PIC16C65B Rev. A Silicon Errata Sheet

The PIC16C65B (Rev. A) parts you have received conform functionally to the Device Data Sheet (DS30605A), except for the anomalies described below.

FIGURE 1: $\overline{\text{MCLR}}$ EXTERNAL CIRCUIT

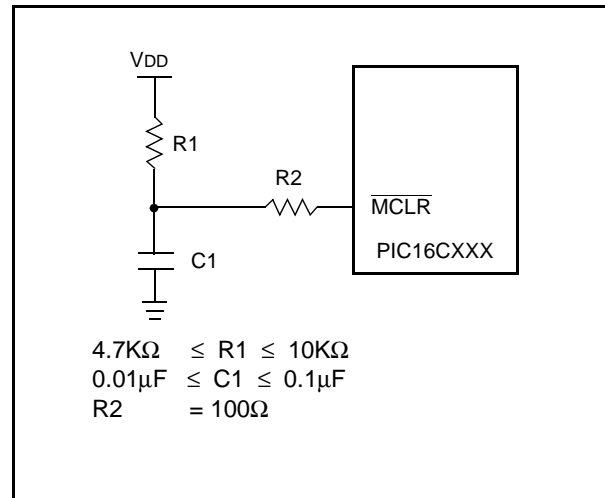
The minimum specification for the $\overline{\text{MCLR}}$ must be met in order to RESET the PIC16CXXX. If a $\overline{\text{MCLR}}$ pulse occurs that is less than the minimum specification (parameter #30), improper device operation can occur.

If the minimum specification cannot be met, then an external circuit must be used to insure that any pulse width less than the specification will be filtered before it reaches the $\overline{\text{MCLR}}$ pin.

A possible circuit is shown in Figure 1. Proper design validation needs to be done to ensure desired operation over the applications operating conditions

Figure 2: Wake-up from Sleep

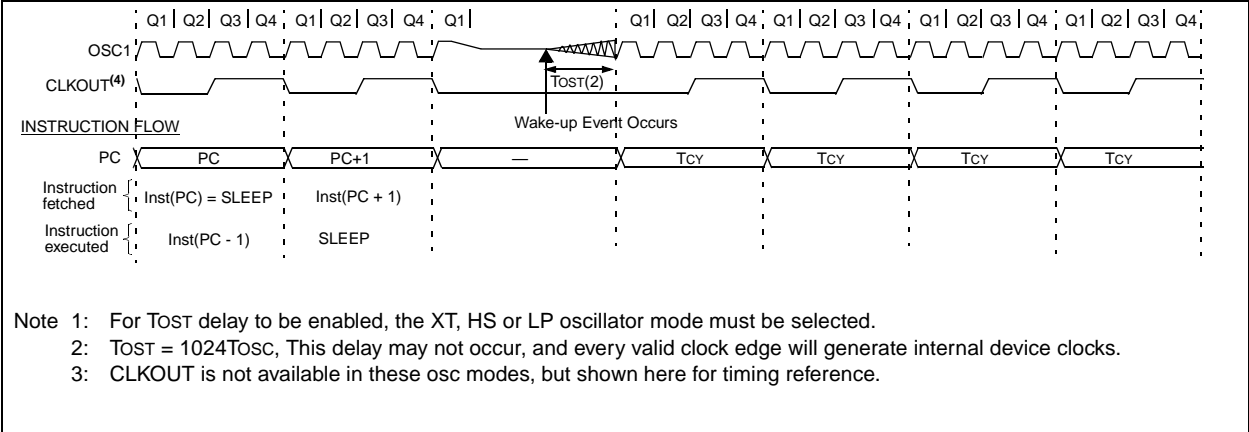
The Oscillator Start-up Timer (TOST) delay may not occur when the device wakes-up from sleep.

Figure 2 shows the start-up of the crystal after the event that causes the device to wake up from sleep mode (as specified in device data sheet). The start-up time (TOST) may not occur.

After the SLEEP instruction, do a software delay of 256 Tcy (same as 1024 TOSC). At the Reset and Interrupt vector addresses, test to see if the device woke from sleep (the $\overline{\text{TO}}$ and $\overline{\text{PD}}$ bits), and if the device did wake from sleep, ensure that the total cycle delay is 256 Tcy.

Figure 3: PIC16CXXX Voltage-Frequency Graph

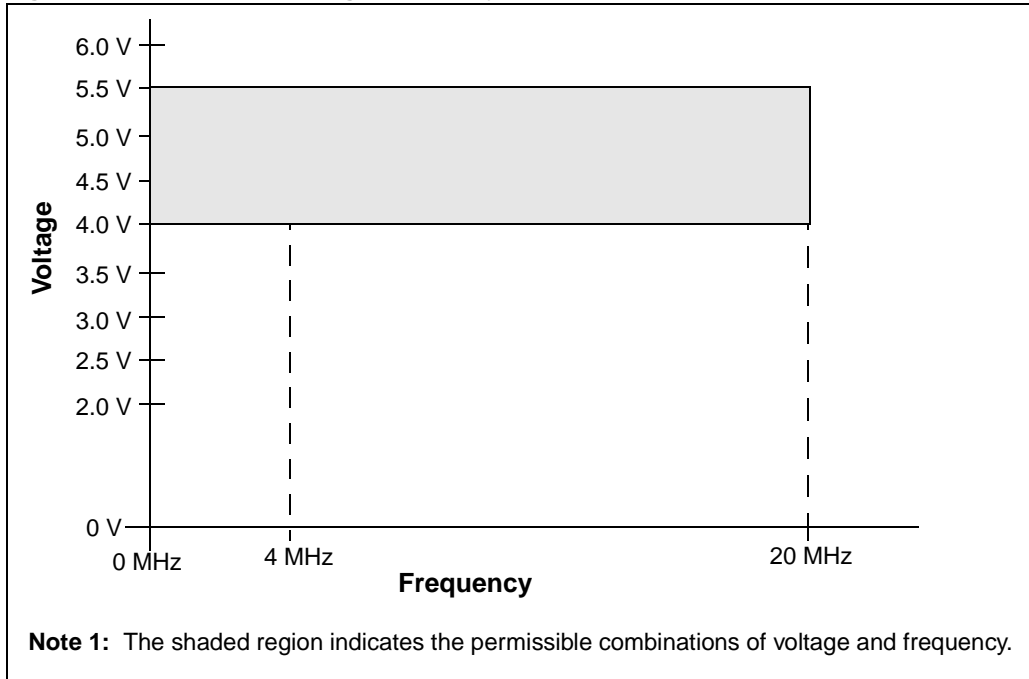
- Figure 3 and Figure 4 are additions to the data sheet to show the area of operation. These figures replace the Cross Reference of Device Specs for Oscillator Modes Table in the Electrical Specification section.

Figure 3 shows the voltage vs. frequency operation for the PIC16CXXX devices. Devices marked with a "-04" operate up to 4 MHz, while devices marked with a "-20" operate up to 20 MHz. The entire shaded region is the valid operating region.

Figure 4: PIC16LCXXX Voltage-Frequency Graph

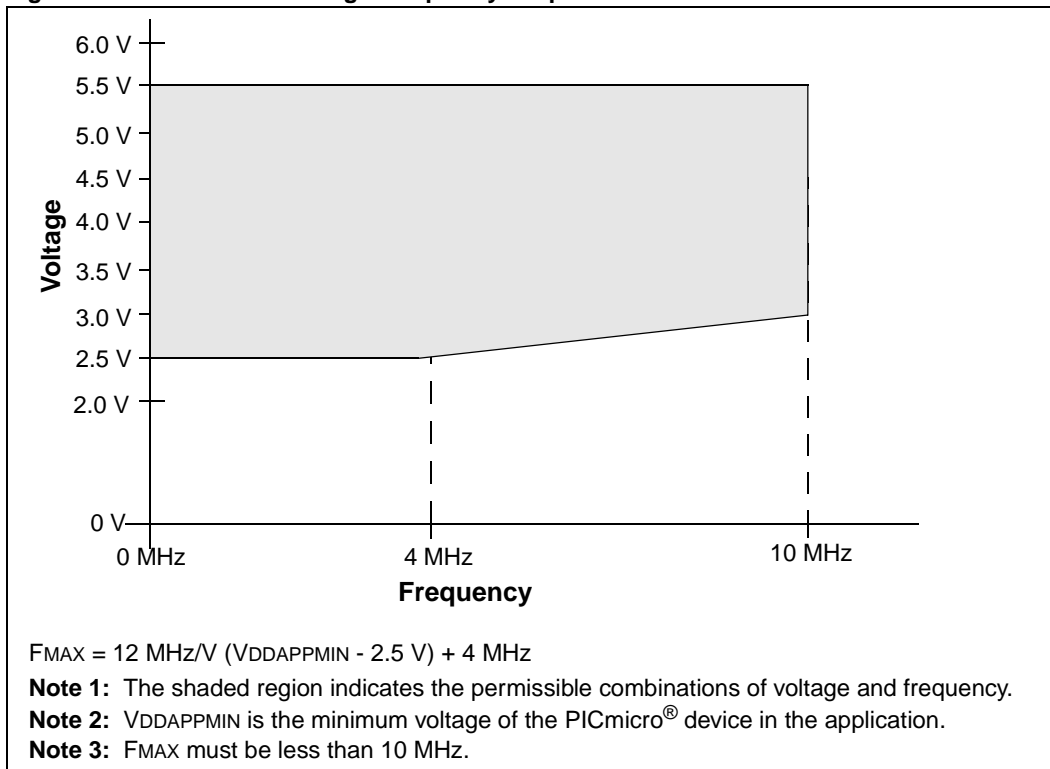
Figure 4 shows the voltage vs. frequency operation for the PIC16LCXXX devices. The devices marked with a "-04" operate up to 4 MHz at the minimum supplied voltage. The devices also operate at a higher frequency (10 MHz) and at a higher voltage (3V). The entire shaded region is the valid operating region.
